RHODE ISLAND DEPARTMENT OF TRANSPORTATION

I-195 Relocation – Contract 16 – Providence River Pedestrian Bridge

NOTICE TO PROSPECTIVE BIDDERS

ADDENDUM NO. 8 Prospective bidders and all concerned are hereby notified of the following changes in the Plans, Specifications, Proposal and Distribution of Quantities for this contract. These changes shall be incorporated in the Plans, Specifications, Proposal and Distribution of Quantities, and shall become an integral part of the Contract Documents.

DESIGNED BY: SB
CHECKED: AN
DATE: 04/21/14
SHEET: V2_095
OF: V2_163

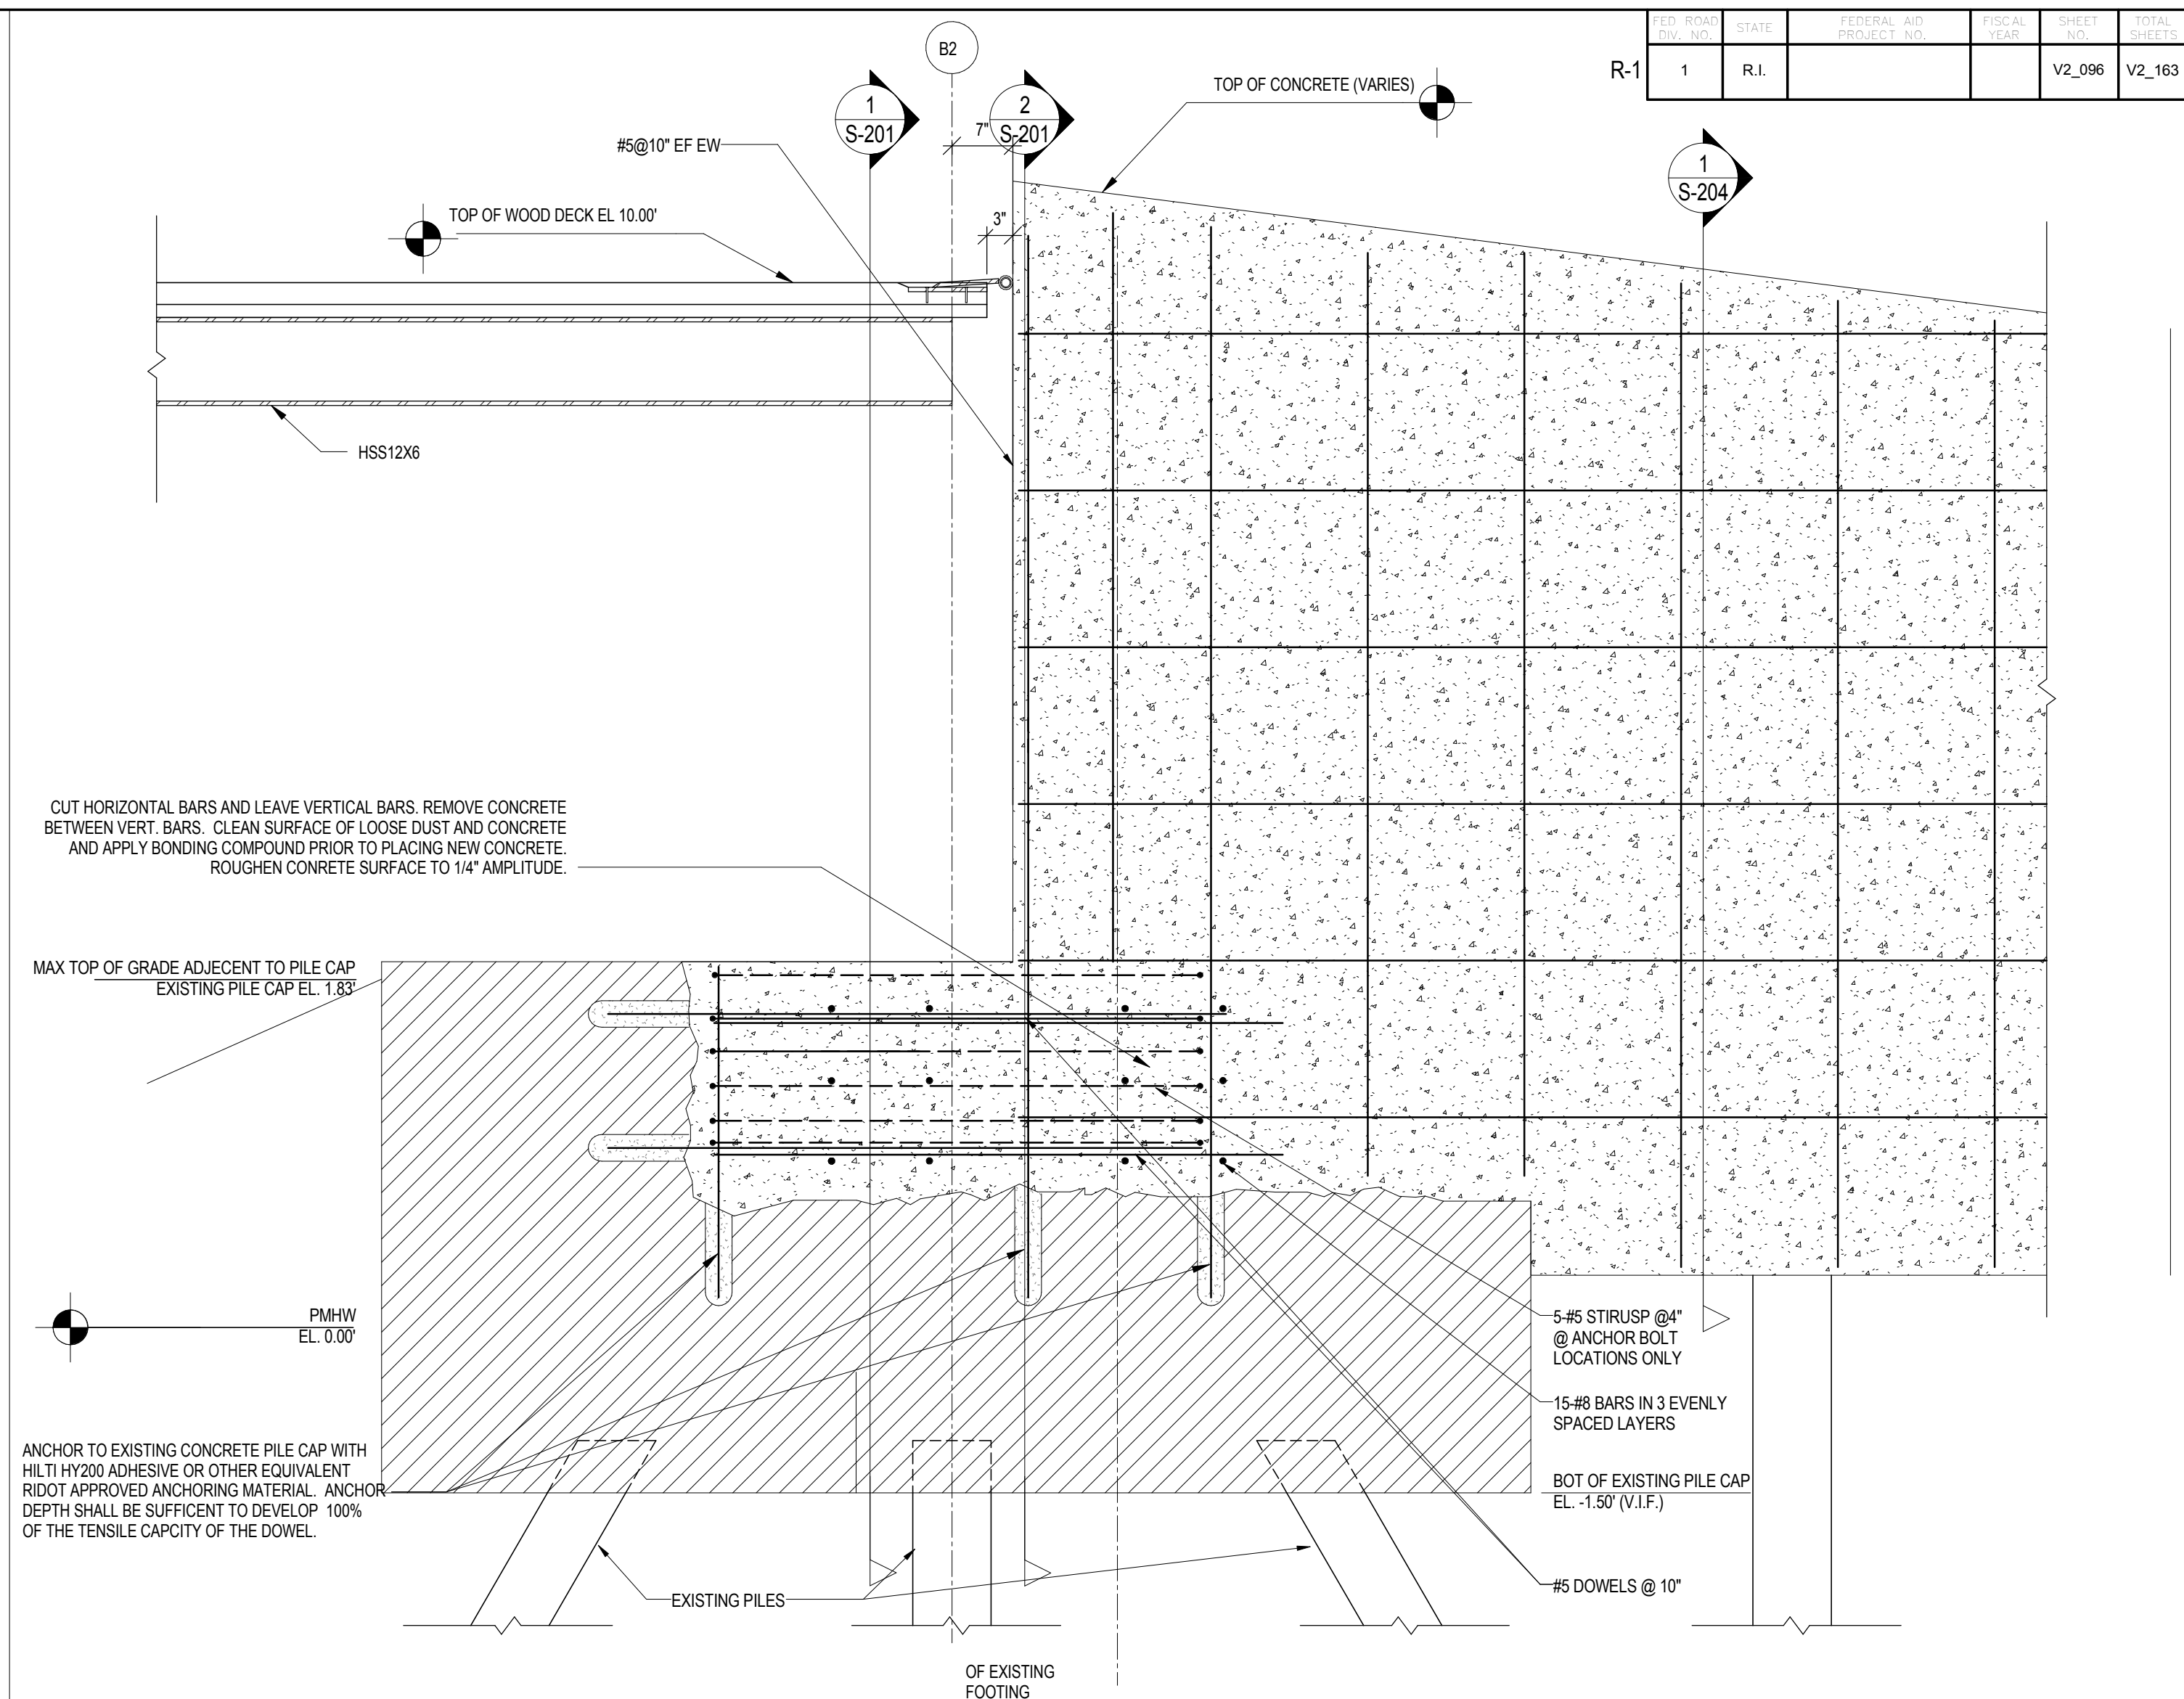
Delete Sheet V2_095 in its entirety and replace it with sheet V2_095(R-1) attached to this Addendum No. 8. A callout for the subbase has been revised.

DESIGNED BY: SB
CHECKED: AN
DATE: 04/21/14
SHEET: V2_096
OF: V2_163

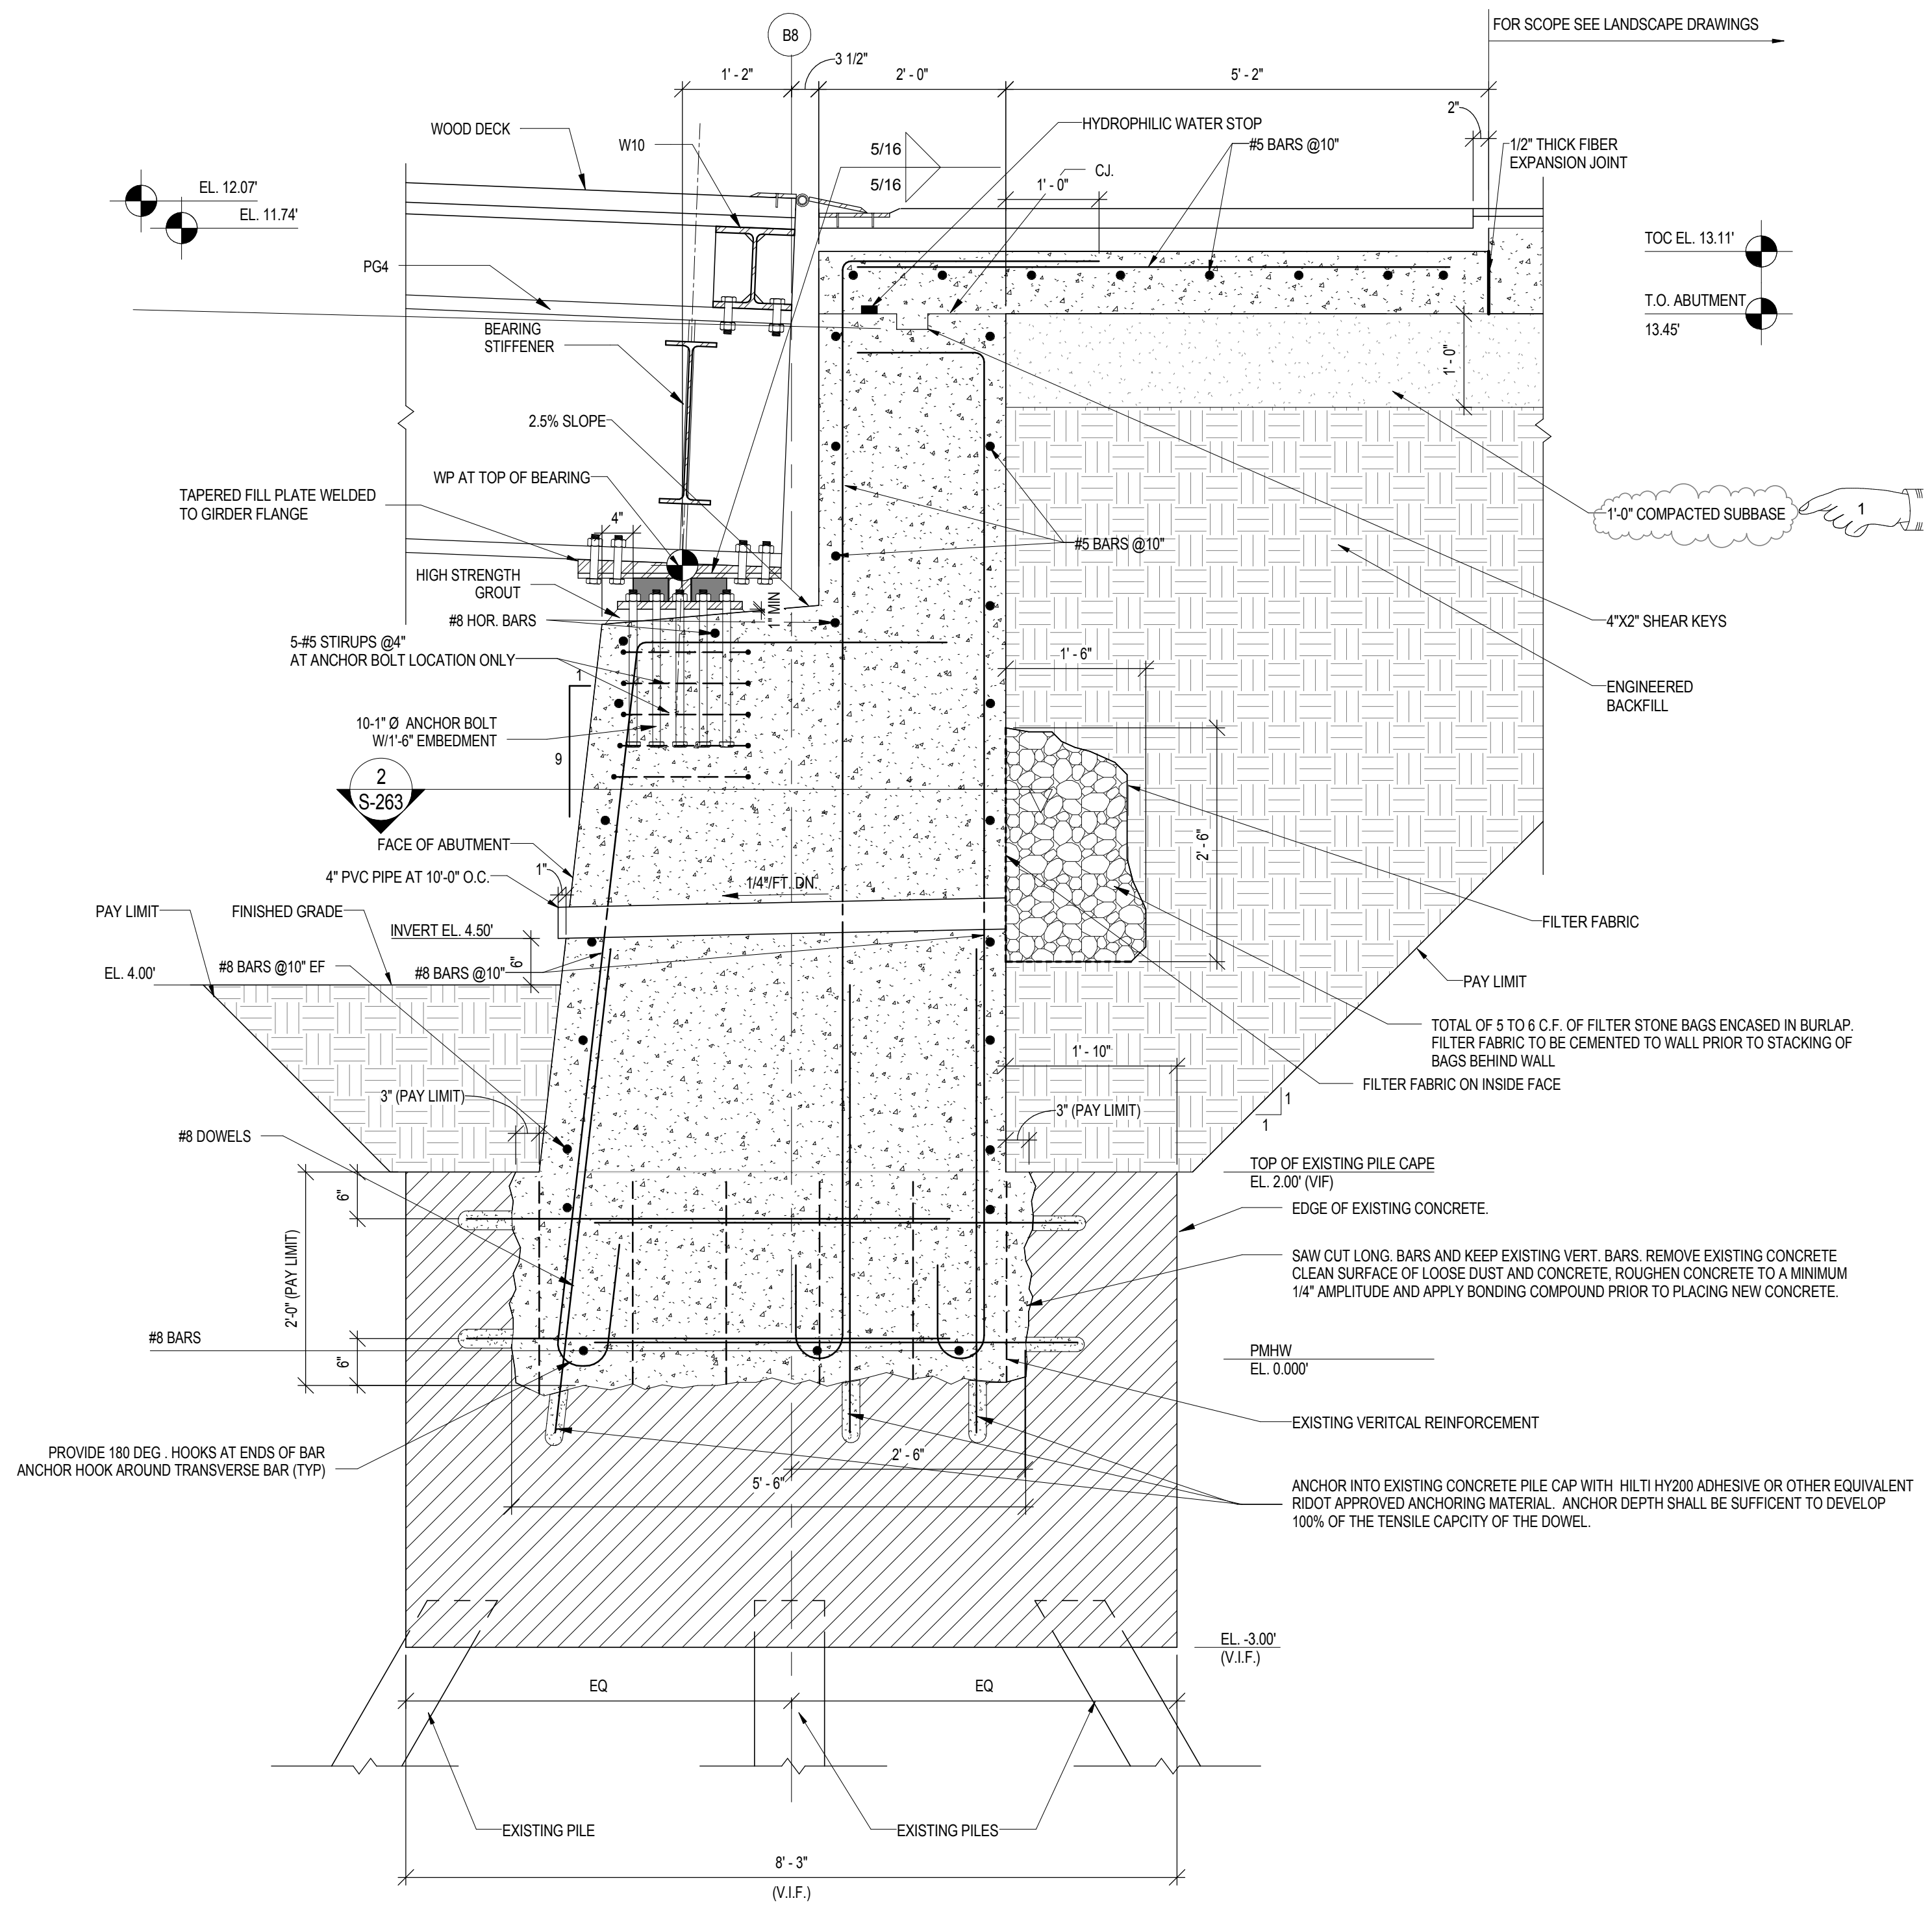
Delete Sheet V2_096 in its entirety and replace it with sheet V2_096(R-1) attached to this Addendum No. 8. A callout for the subbase has been revised.

DESIGNED BY: AN
CHECKED BY: AN
DATE: 04/21/14
SHEET: V2_116
OF: V2_163

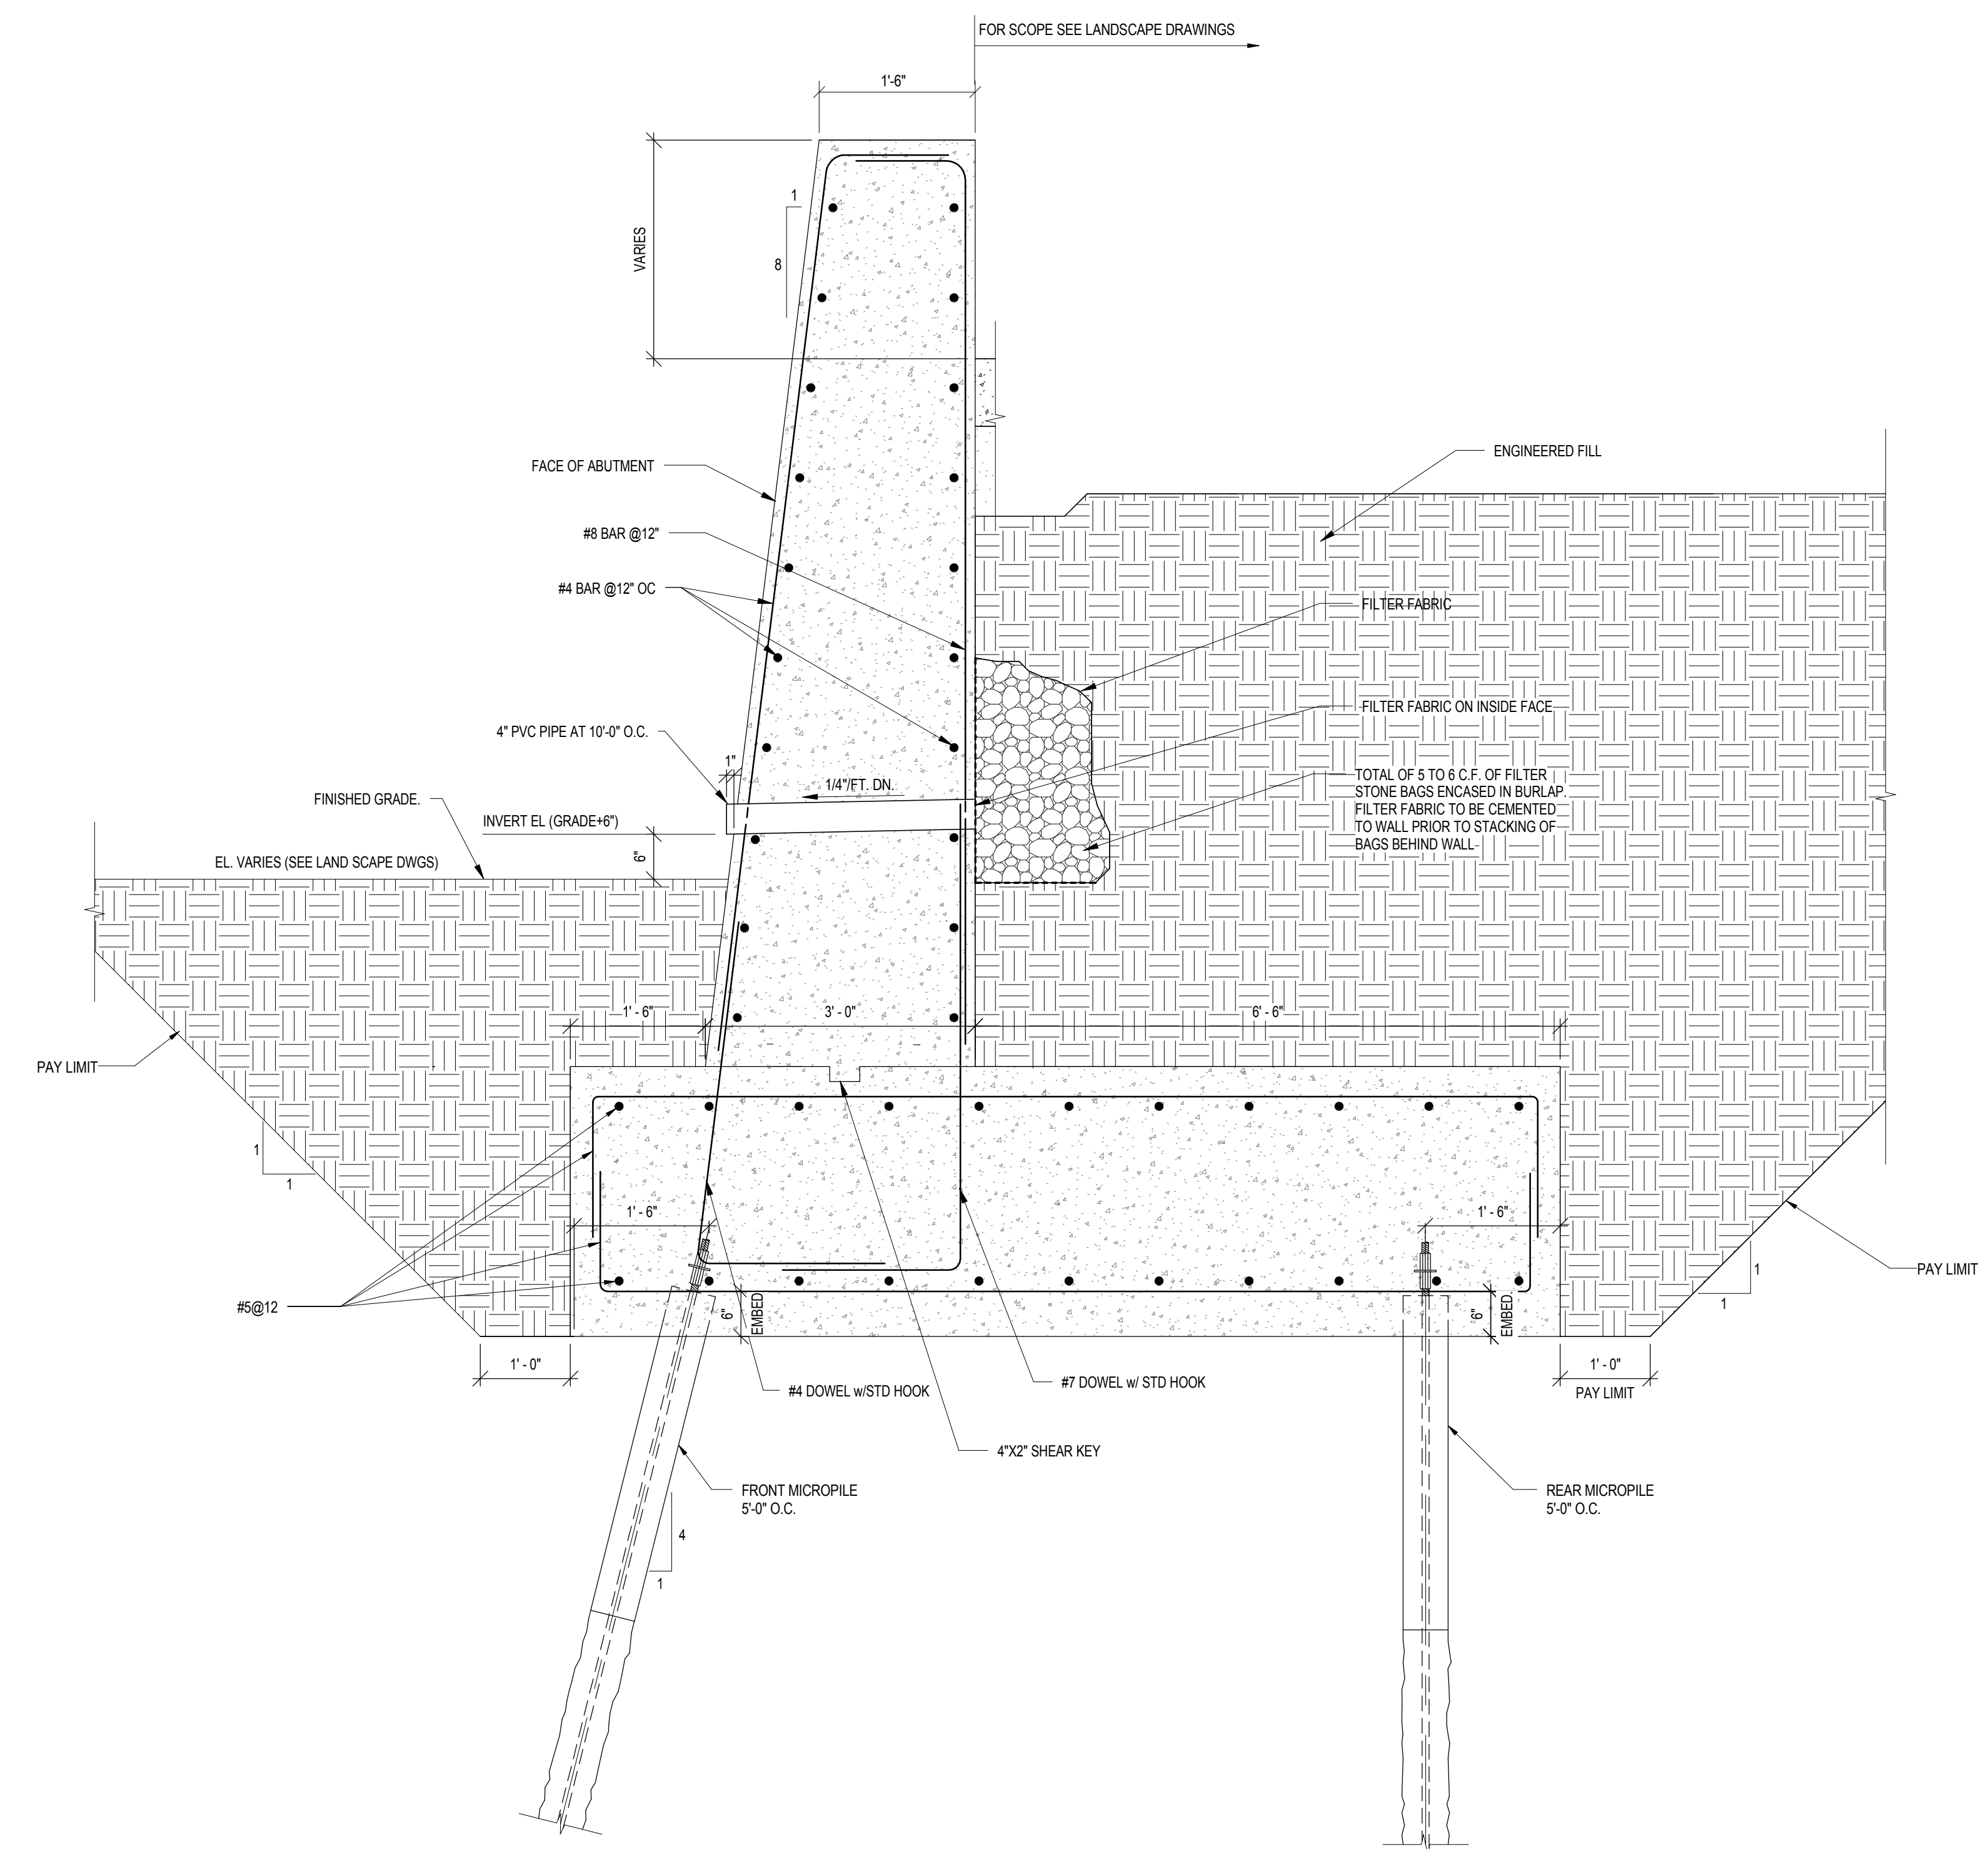
Delete Sheet V2_116 in its entirety and replace it with sheet V2_116(R-1) attached to this Addendum No. 8. A callout for the subbase has been revised.
